LOST CREEK ISR, LLC

**Re: Submittal of Responses to 4th Round Comments
TFN 4 6/268**

**RESPONSES TO OCTOBER 2010 WDEQ/LQD COMMENTS
ON
THE MAIN PERMIT DOCUMENT**

**for the
LOST CREEK PROJECT
Wyoming**

MB-07

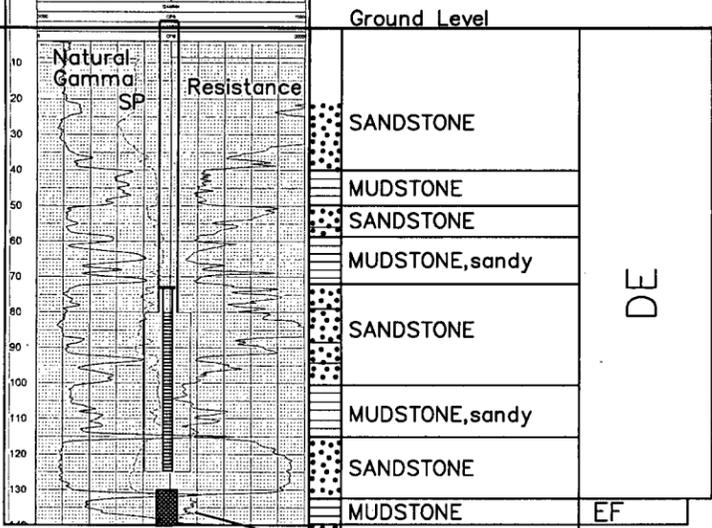
LQD (12/09) - LC added a page at the beginning of Attachment D6-3 to explain some of the drill log discrepancies. The page is titled "Notes on the Well Completion Logs in Attachment D6-3". In the first paragraph, please explain in further detail the penetration into the EF shale at wells MB-1 and MB-7. Specifically, how far into the shale did each drill hole penetrate, and what is the approximate thickness of the shale at the location.

LC ISR, LLC (6/10) - A detailed review of the stratigraphy of well MB-7 indicates that the EF shale had been improperly fully penetrated by the pilot hole. LC ISR, LLC has no records to indicate that the rat-hole below the well screen has been back-plugged. Although well MB-07 has insufficient water to sample, it is important that the well's completion is correct. Therefore, LC ISR, LLC will pull the screen and back-plug the rat-hole with grout and then re-set the screen. Water levels will continue to be collected to see if sufficient water is available for well development and sampling. If sufficient water is available, the well will be sampling in accordance with the standard presented in the Operations Plan.

LC ISR, LLC (9/10) - LC ISR, LLC plans to physically check the completion of well MB-07 during the 2010 drilling season and will inform WDEQ-LQD of the results of this check.

FIGURE OP-6b
Vegetation and Soil Impacts
Due to Excavation
Lost Creek Permit Area

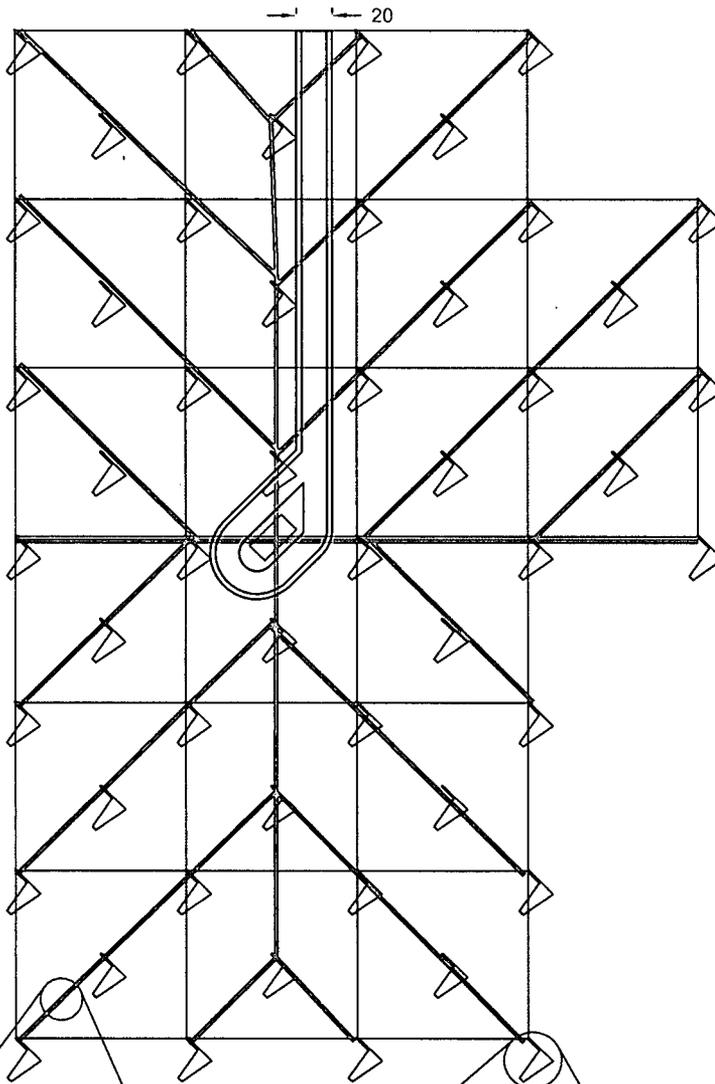
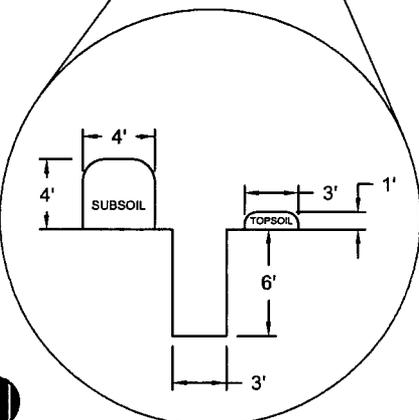
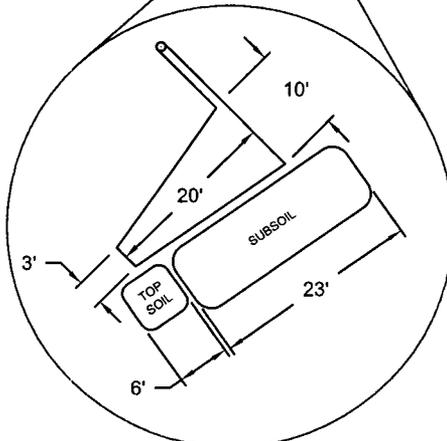
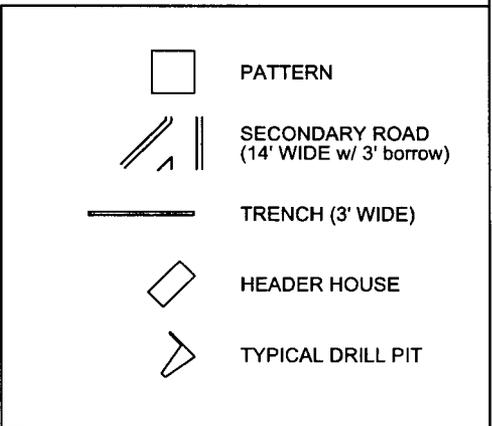
The attached site map (enclosure) of Mine Unit One is representative of the disturbance prior to any header houses, roads or pipelines and is indicative of how significant the surface impacts will be. Although long and short term disturbances are broken out separately on Figure OP-6b, the reality is that even the short term disturbances will have long term impacts due to the time it takes to reach reclamation success.

LC ISR, LLC (6/10) - The original intent of Figure OP-6b was to show how operations will be designed in a generic sense. In fact, the actual wellfield layout will not be as symmetrical as that shown in the figure. Given the size of the equipment used, current state of knowledge and the density of drilling, it is impossible to define at this point in time where all disturbance will be other than to say that disturbance from construction and operations will be limited generally to the pattern area and utility routes.

LC ISR, LLC (9/10) - A new figure (Figure OP-6c) has been added to provide a more detailed presentation of the topsoil disturbance within the wellfield. Figure OP-6b shows the installation of lateral pipelines with the aid of a backhoe; however, LC ISR, LLC reserves the right to use a trenching device to install lateral lines from the wellheads to the header house. The use of a trencher will result in significantly less disturbance than that shown in Figure OP-6b.

LC ISR, LLC (11/10) – As requested, the title to Figure OP-6b has been revised.
